<b>Well Name:</b> BURCH KEELY UNIT	<b>Well Location:</b> T17S / R29E / SEC 23 / SWNE /	<b>County or Parish/State:</b> EDDY / NM
<b>Well Number:</b> 69	<b>Type of Well:</b> INJECTION - ENHANCED RECOVERY	<b>Allottee or Tribe Name:</b>
<b>Lease Number:</b> NMLC028784B	<b>Unit or CA Name:</b> BURCH KEELY UNIT	<b>Unit or CA Number:</b> NMNM88525X
<b>US Well Number:</b> 3001503054	<b>Well Status:</b> Water Injection Well	<b>Operator:</b> SPUR ENERGY PARTNERS LLC

Notice of Intent

Burch Keely Unit #69  
Eddy County, NM  
API# 30-015-03054

P&A Procedure

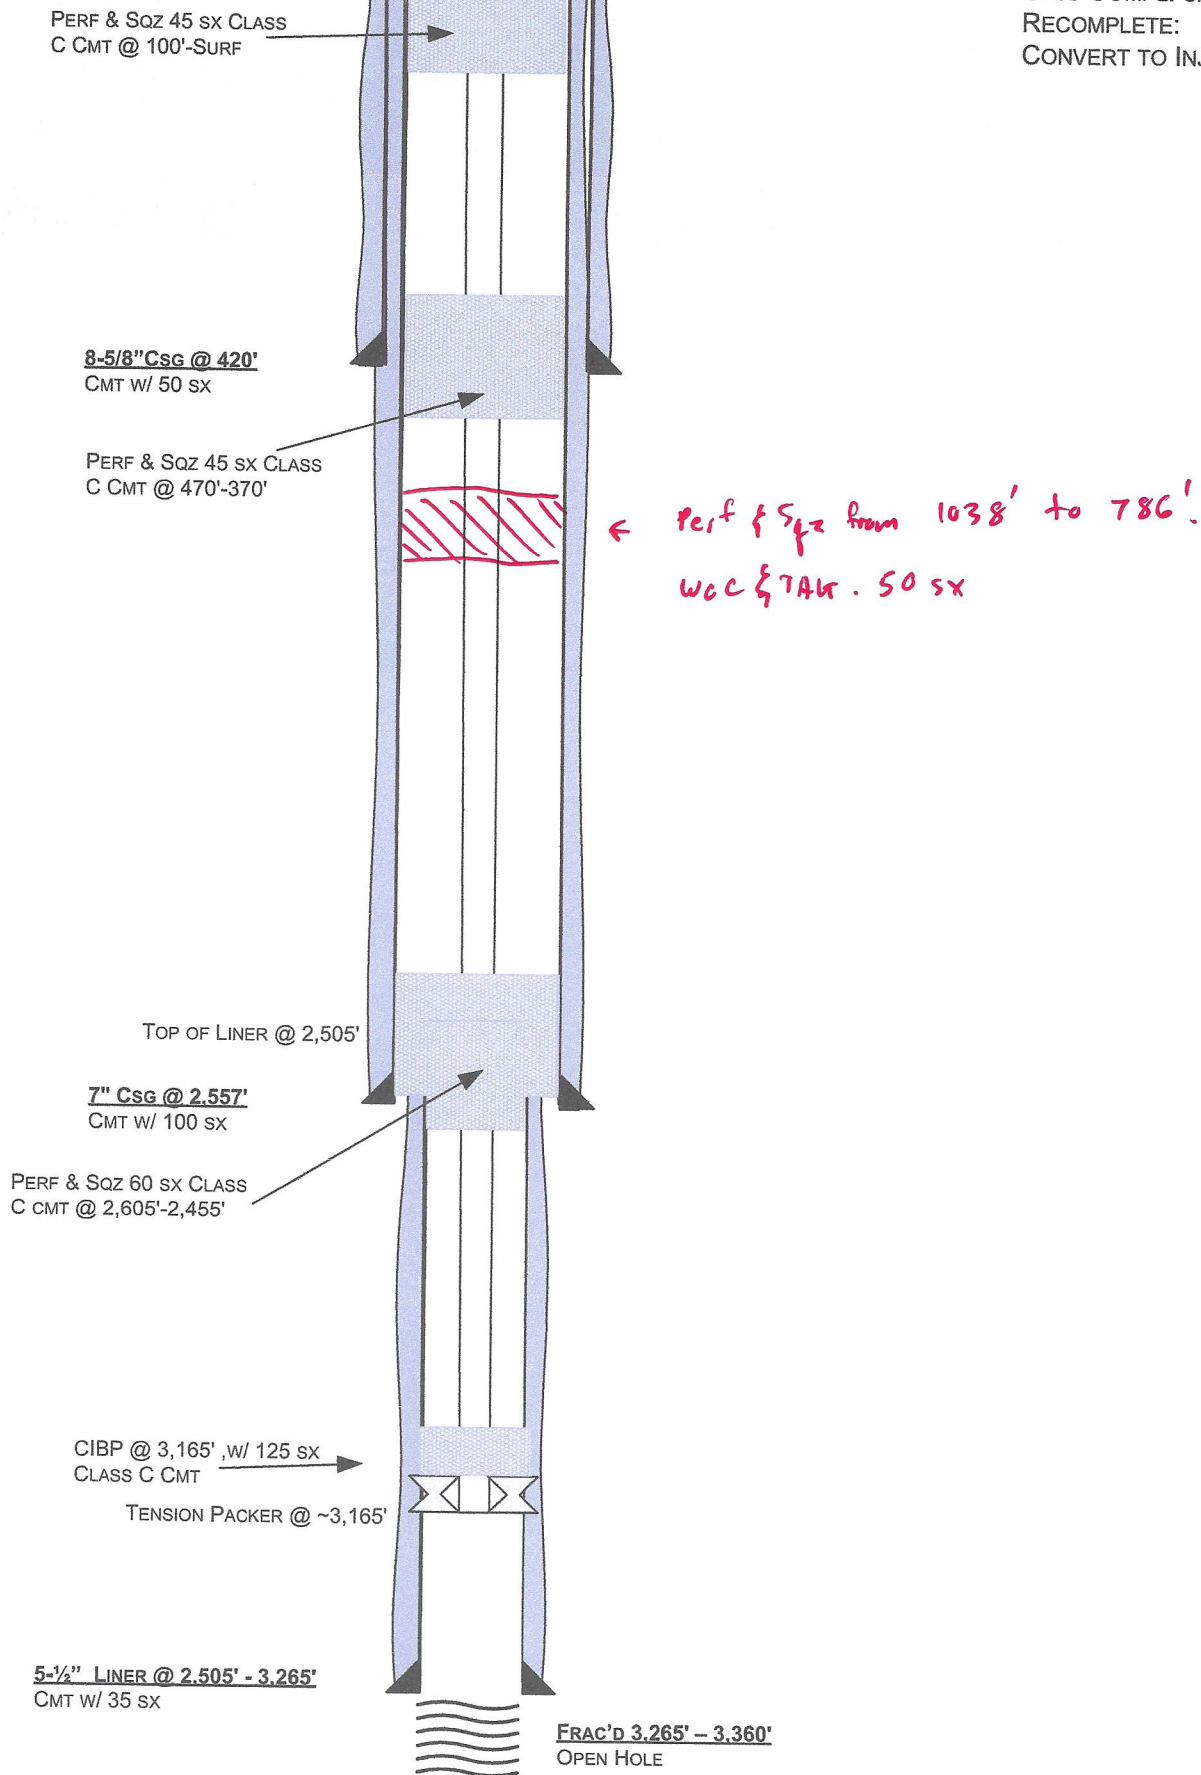
Perf & Sqz from 1038' to 786'. WOC & TAG (50 sx)  
(Tates & B. Salt)

Plug Type	Top	Bottom	Length	Tag	Sacks	Notes
Surface Plug	0.00	100.00	100.00	Tag/Verify	45.00	Perf and Squeeze at 100' to surface. Verify at Surface.
Top of Salt @ 378	324.22	428.00	103.78	Tag/Verify		
Shoe Plug	365.80	470.00	104.20	Tag/Verify	45.00	Perf and Squeeze at 470' to 370'. WOC and Tag
Base of Salt @ 845	786.55	895.00	108.45	Tag/Verify		
Yates @ 988	928.12	1038.00	109.88	If solid base no need to Tag (CIBP present and/or Mechanical Integrity Test), If Perf & Sqz then Tag, Leak Test all CIBP if no Open Perforatio	50.00	Perf and Squeeze from 1038' to 786'. WOC and Tag.
Top of Liner @ 2505	2429.95	2555.00	125.05	If solid base no need to Tag (CIBP present and/or Mechanical Integrity Test), If Perf & Sqz then Tag, Leak Test all CIBP if no Open Perforatio		
Shoe Plug	2481.43	2607.00	125.57	Tag/Verify	60.00	Perf and Squeeze from 2605' to 2429'. WOC and Tag.

If solid base no need to Tag (CIBP present and/or Mechanical Integrity Test), If Perf & Sqz then Tag, Leak Test all CIBP if no Open Perforatio		
CIBP Plug	3130.00	3165.00	35.00	Perforatio	125.00	Spot 125 sacks. WOC and Tag.
Shoe Plug	3182.35	3315.00	132.65	Tag/Verify		
				If solid base no need to Tag (CIBP present and/or Mechanical Integrity Test), If Perf & Sqz then Tag, Leak Test all CIBP if no Open Perforatio		
Glorieta @ 4001	3910.99	4051.00	140.01	Perforatio

Critical, High, Medium, Secretary : Top of salt to surface **If no salt take the deepest fresh water.**

R111P: 50' from bottom of salt to surface
